## **FIRE SAFETY STUDY - ADDENDUM 1**

### **SMITHFIELD BATTERY ENERGY STORAGE SYSTEM**

**DOCUMENT NO: 21895-RP-002**

**Table 1.1: FRNSW FSS Comments - Iberdrola Response**

Figure D.1: Fully developed BESS fire-heat radiation impact

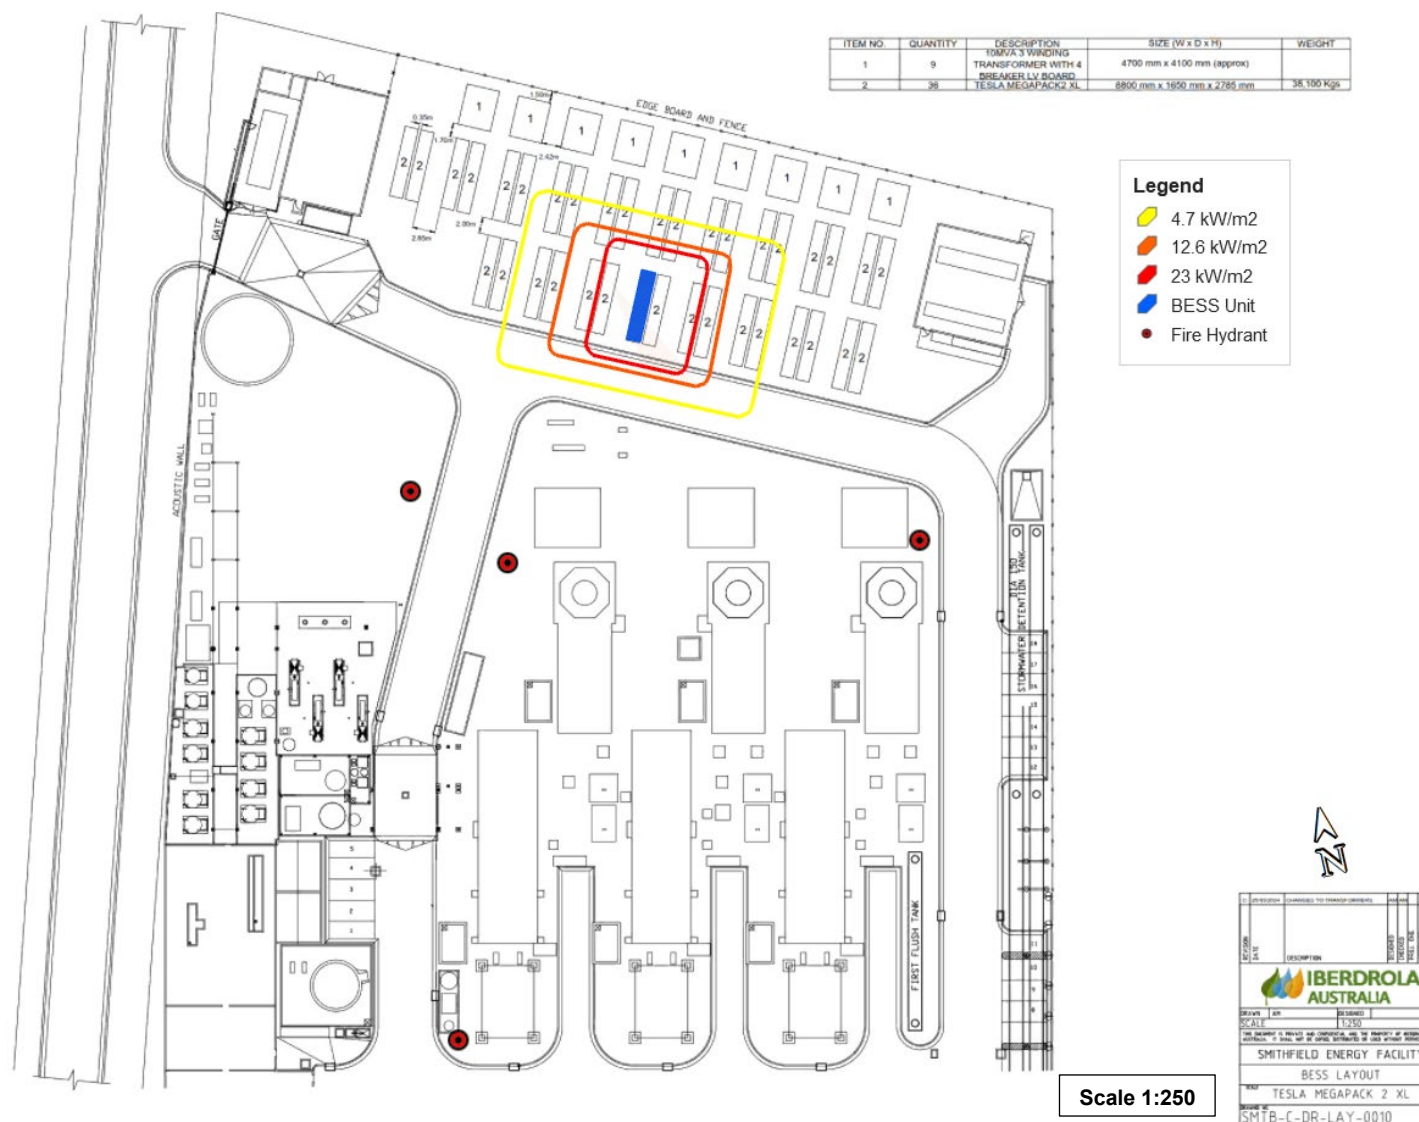
| FSS Section   | Fire Safety Study Comment<br>(provided by FRNSW)                                                                                                                                  | FRNSW Comment                                                                                                                                                                                                                                                                                                                                                                                                    | Iberdrola Response                                                                                                                                                                                                                                                                                                                                                                                                                                                                                                                                                                                                                                                                                                                                                                       |
|---------------|-----------------------------------------------------------------------------------------------------------------------------------------------------------------------------------|------------------------------------------------------------------------------------------------------------------------------------------------------------------------------------------------------------------------------------------------------------------------------------------------------------------------------------------------------------------------------------------------------------------|------------------------------------------------------------------------------------------------------------------------------------------------------------------------------------------------------------------------------------------------------------------------------------------------------------------------------------------------------------------------------------------------------------------------------------------------------------------------------------------------------------------------------------------------------------------------------------------------------------------------------------------------------------------------------------------------------------------------------------------------------------------------------------------|
| Section 6     | General Comment                                                                                                                                                                   | <p>FRNSW recommends diagrams showing worst-case scenario heat flux distances, explosion overpressures and toxicity effects be included for all consequence analysis conducted within the FSS.</p> <p>The diagrams should also indicate the location of fire hydrants and other firefighting infrastructure and demonstrate that a credible fire scenario will not impact safe operation of the firefighters.</p> | <p>Diagrams showing the worst case scenario heat flux distances (with no mitigation controls) is shown in Appendix D covering:</p> <ul style="list-style-type: none"> <li>Fully developed BESS fire</li> <li>BESS transformer fire</li> <li>SEF Gas Yard fire directed towards the BESS facility.</li> </ul>                                                                                                                                                                                                                                                                                                                                                                                                                                                                             |

- Fully developed BESS fire (Figure D.1)
- HF maximum impact area from BESS fire (Figure D.2)
- BESS transformer fire (Figure D.3)
- SEF Gas Yard fire directed towards the BESS facility (Figure D.4 to Figure D.7).
